AS SUBDIVISION, RESUBDIVISION OF LOTS 1 & 3

APPLICATION NUMBER 10 DATE November 21, 2013

REQUEST Subdivision

DETAIL SITE PLAN

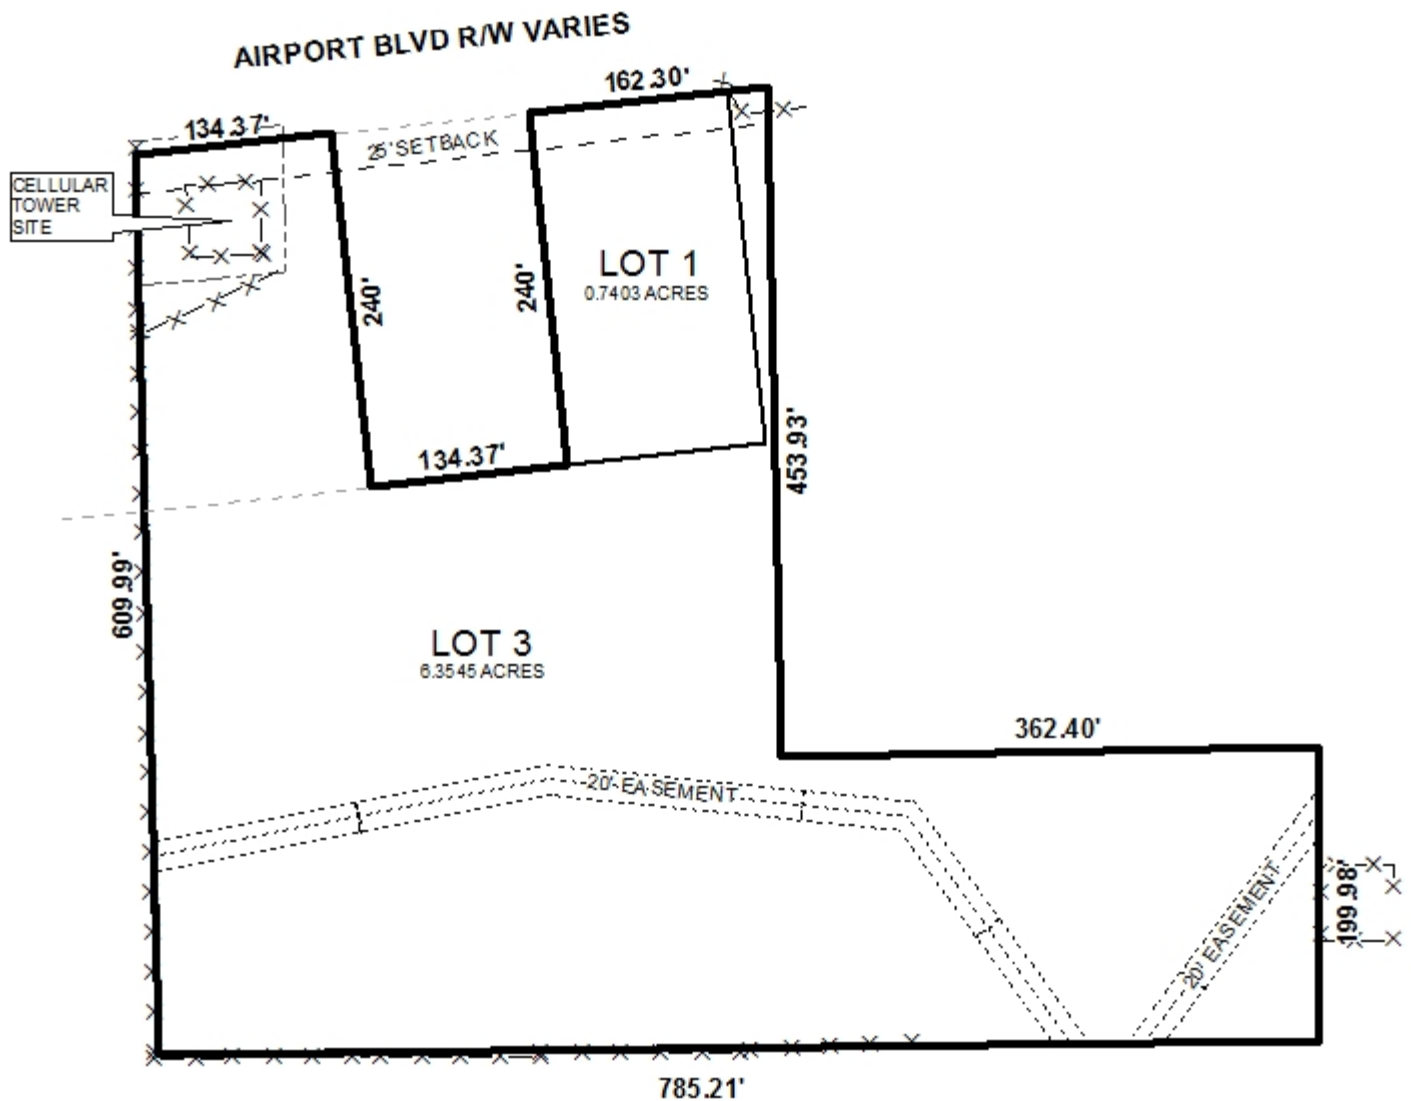
The site fronts on Airport Boulevard, a major street, as illustrated on the Major Street Plan with a planned 100-foot right-of-way. The plat indicates the right-of-way width on Airport Boulevard varies however, a 50' right-of-way width is illustrated on the plat. If approved, the 50' right-of-way should be retained on the Final Plat.

The 25' minimum building setback line is indicated on the preliminary plat; and should be retained on the Final Plat, if approved.

The previous plat proposed two curb-cuts for the 3 lot subdivision with Lots 1 and 2 sharing a curb-cut, and Lot 3 having its own curb-cut. The preliminary plat does not reflect any new curb-cuts. Thus, as a means of access management and to allow the developer more flexibility, there should be a note on the Final Plat limiting each lot to a total of two curb-cuts with the location, size and design to be approved by Mobile County Engineering and to conform to AASHTO standards.

As proposed Lot 1 does not completely extend to the eastern property line, thus a portion of Lot 3 has frontage to the East of Lot 1, as well as to the West of Lot 1. The plat should be revised to eliminate that portion of Lot 3 between Lot 1 and the eastern property line, to eliminate the small

pole illustrated on the plat between the proposed Lot 1 and the adjacent property. It should be noted that the remaining piece of Lot 3, between Lot 1 and the east property line, ranges from 10' to 25' in width. Thus, eliminating the small pole portion of Lot 3, east of Lot 1, is recommended.

It should be noted the lot sizes are labeled in acres and square feet; this should be retained of the final plat.

It should also be noted the proposed Lot 3 currently has drainage easements that run throughout property. There is a note located on the preliminary plat that states, *"this easement is temporary drainage easement for Mobile County, this easement will remain in the county name until such time as the existing drainage is improved per plans approved by Mobile County, at which time the easement will revert back to the property owner"*. However a note should be placed on the Final Plat stating no structures shall be constructed or placed in any easements.

- 1) placement of a note on the Final Plat limiting the lots to a combined total of 2 curb-cuts with the location, size and design to be approved by Mobile County Engineering and to conform to AASHTO standards;
- 2) retention of 50' right-of-way width as depicted from centerline of Airport Boulevard on the Final Plat;
- 3) retention of 25-foot minimum building setback line on the Final Plat;
- 4) revision of the plat to eliminate the pole portion of Lot 3, East of Lot 1;
- 5) revision of the lot sizes in acres and square feet on the Final Plat to reflect changes required by number 4;

- 6) placement of a note on the Final Plat stating no structures shall be constructed or placed in any easements;
- 7) placement of a note on the Final Plat stating that approval of all applicable Federal, state and local agencies is required for endangered , threatened or otherwise protected species, if any, prior to the issuance of any permits or land disturbance activities;

- 8) placement of a note on the Final Plat stating that any lots which are developed commercially and adjoin residentially developed property must provide a buffer, in compliance with Section V.A.8. of the Subdivision Regulations;

- 9) placement of a note on the Final Plat stating that development *“Must comply with the Mobile County Flood Damage Prevention Ordinance. Development shall be designed to comply with the storm water detention and drainage facility requirements of the City of Mobile storm water and flood control ordinances, and requiring submission of certification from a licensed engineer certifying that the design complies with the storm water detention and drainage facility requirements of the City of Mobile storm water and flood control ordinances prior to the issuance of any permits.”*and

- 10) retention of all other existing notes depicted on the preliminary plat to be illustrated on the Final Plat.
